**CITY OF TEMPE
DEVELOPMENT REVIEW COMMISSION**

**Meeting Date: 10/14/2014
Agenda Item: 3**

ACTION: Request for a Development Plan Review consisting of a new restaurant for TEXAS ROADHOUSE AT EMERALD CENTER, located at 8510 South Emerald Drive. The applicant is Catherine Otis, GreenbergFarrow.

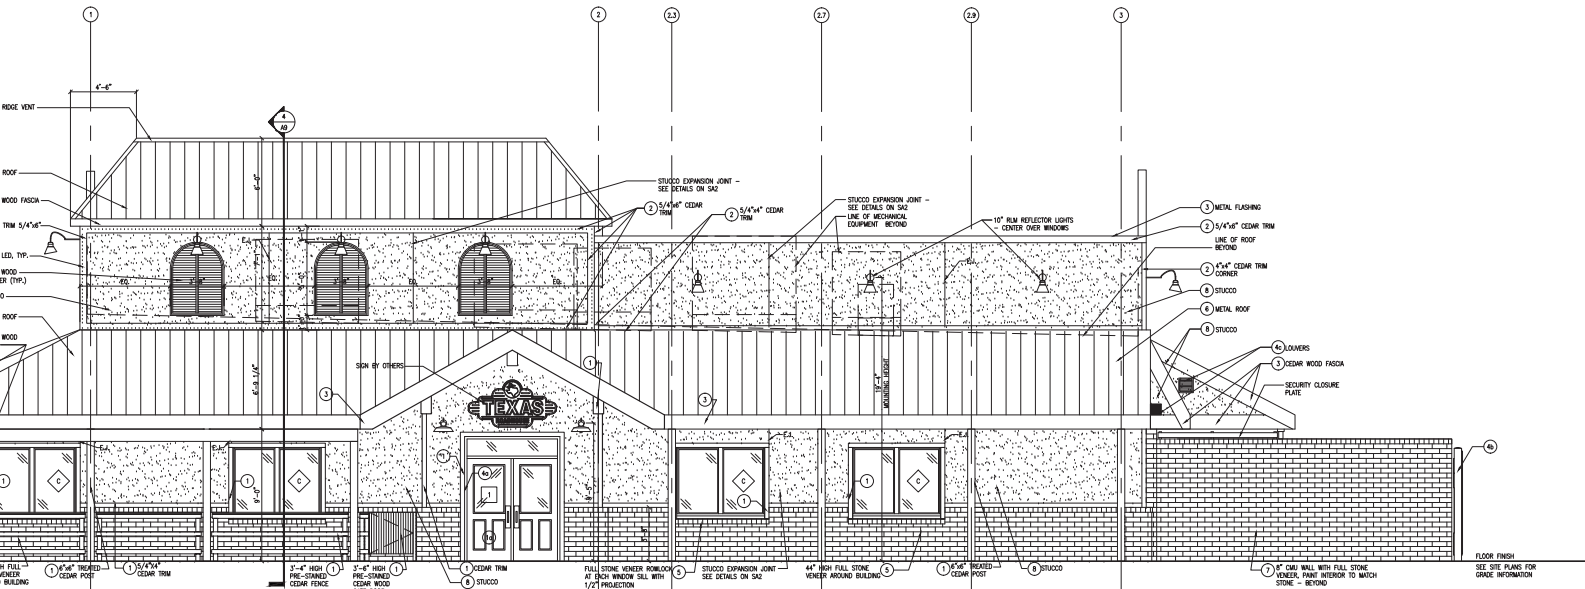
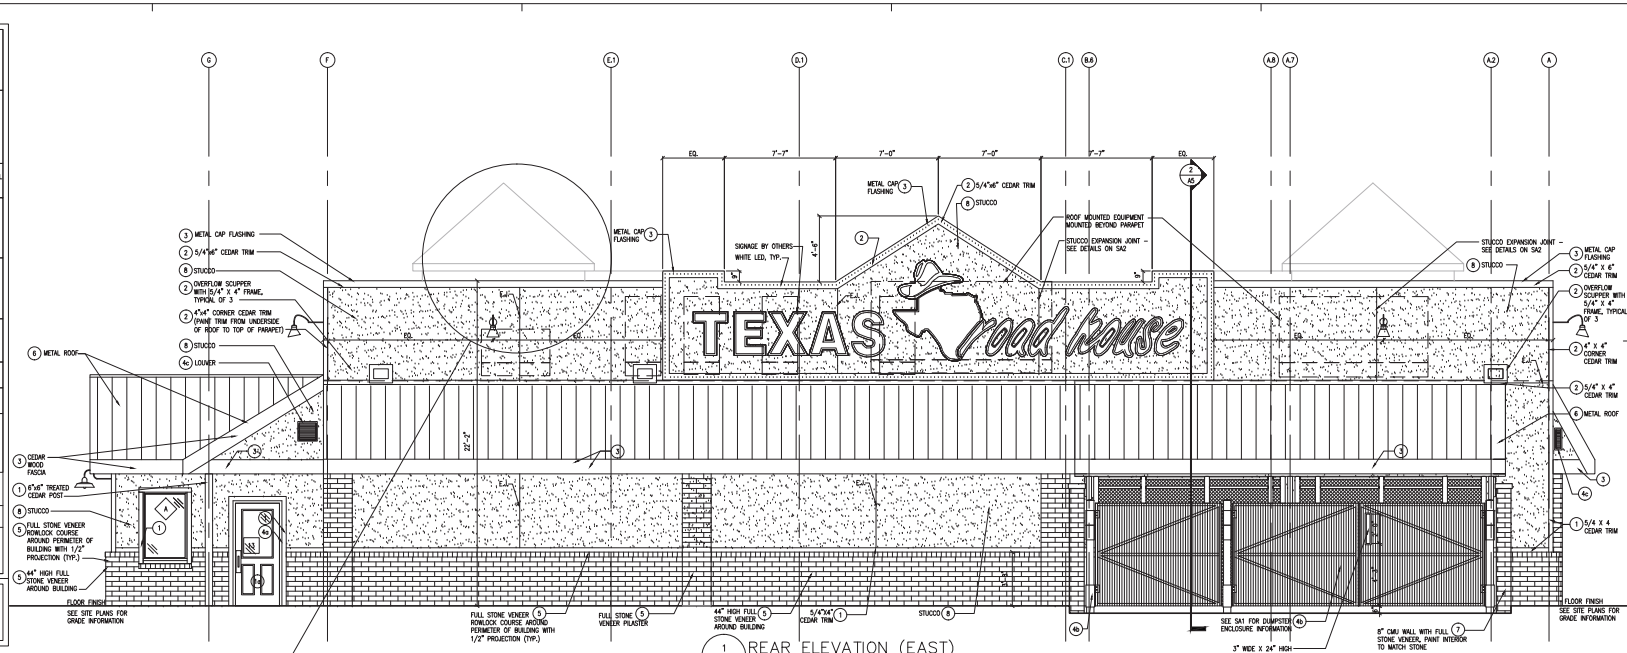
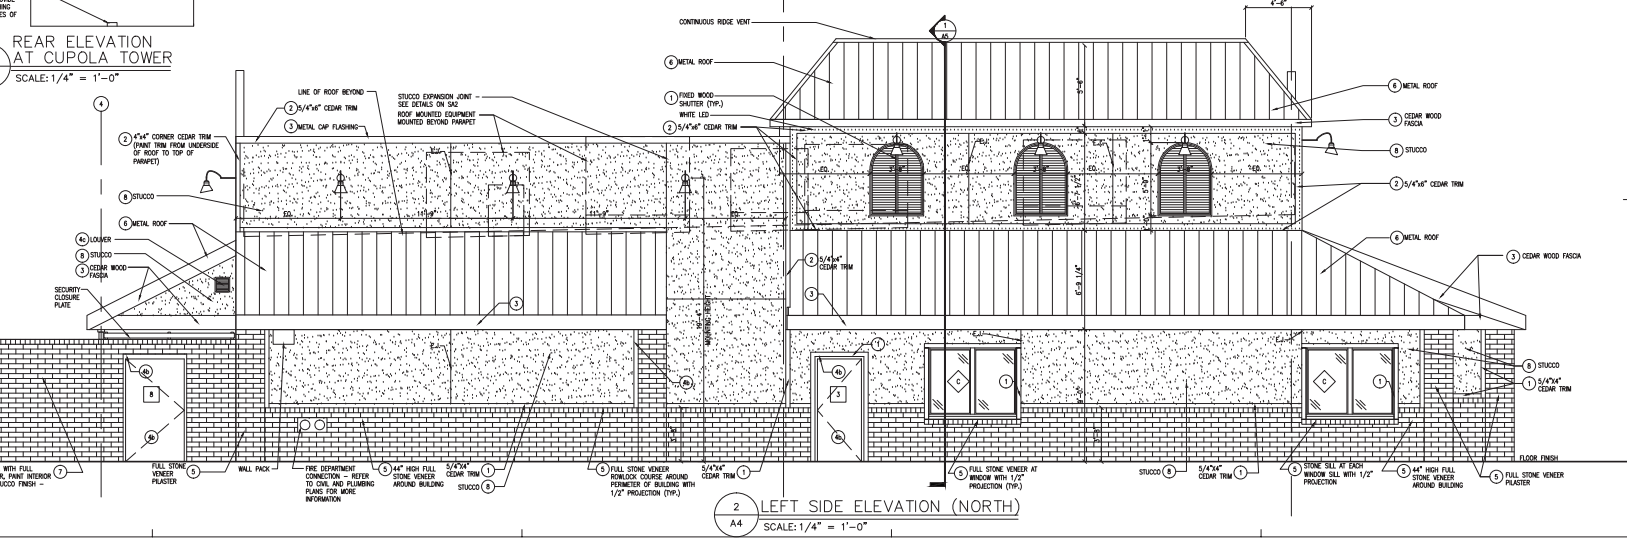
Staff recommended using metal building trim instead of wood, which has been considered a less durable product. However, recent trends in the use of wood in a commercial building façades indicate this is a new style that architects wish to incorporate for a more rustic, industrial, rural or textural change from earlier design aesthetics. Wood is not characteristically used in Emerald Center. Wood is typically allowed as a patio material, but in this case is proposed as an applied building trim element that is characteristic of the architecture of the building and the corporate image of this restaurant.

Staff recommended removal of gutter downspouts and the uplighting on the roof; these changes were made on a resubmittal. Staff recommended removal of LED track lights outlining the building along the green wood trim, and recommended a recessed channel of lighting that would wash the façade of the building rather than outline the architecture. The proposed lighting is not consistent with the surrounding Emerald Center lighting; however the property owner indicated support of the LED lighting proposed. Staff has a lighting condition to provide a recessed architecturally integrated design solution.

11. *Lighting is compatible with the proposed building(s) and adjoining buildings and uses, and does not create negative effects. Elevations do not show lighting design solutions. Staff has conditioned that LED lighting at the building perimeter be changed to recessed channel lights. Adding lighting to this area will provide greater safety to existing businesses*

6. The materials and colors are approved as presented:
The roof color shall match the color of the design presented and approved by the property owner.
Roof (6 on legend)– Fabral "thin seam" standing seam metal roof in Charcoal Grey S01
Main Building (8 on legend)– Sand finished stucco painted Sherwin Williams paint to match Dunn Edwards Boutique Beige
Wainscot (5 on legend) - Stone- Cantera Stone "Tobacco Brown" 4" x 12" utility block
Trim (2 on legend)– cedar wood trim painted Sherwin Williams green (code provided for custom color)
Metal flashing and Fascia (3 on legend) – painted Sherwin Williams green (code provided for custom color)
Trim and Shutters (1 on legend) – prestained cedar wood, cedartown TWP #1501 stain formula
Front Entry Door (1a on legend) – Faux wood metal door Ceco Door Madera CS-5

7. Provide secure roof access from the interior of the building. Do not expose roof access to public view.
8. Conceal roof drainage system within the interior of the building.
9. Incorporate lighting, address signs, and incidental equipment attachments (alarm klaxons, security cameras, etc.) where exposed into the design of the building elevations. Exposed conduit, piping, or related materials is not permitted.
